**DSOX4034A-01**

**S E R V I C E N O T E**

4000 X-Series Scopes

**A replacement of the power supply cover is needed when the cabinet assembly is replaced.**

Power Supply Cover 54695-00103

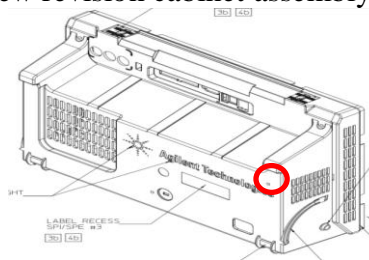
2. If the cabinet assembly is the new revision, proceed with repair as normal
3. If the cabinet assembly is the old revision
  - a. Replace the power supply cover (54695-00103) with new revision
  - b. Replace cabinet assembly as usual (54709-64401)
  - c. Insert screw (0515-0380) into the new screw hole on the cabinet assembly (circled below)
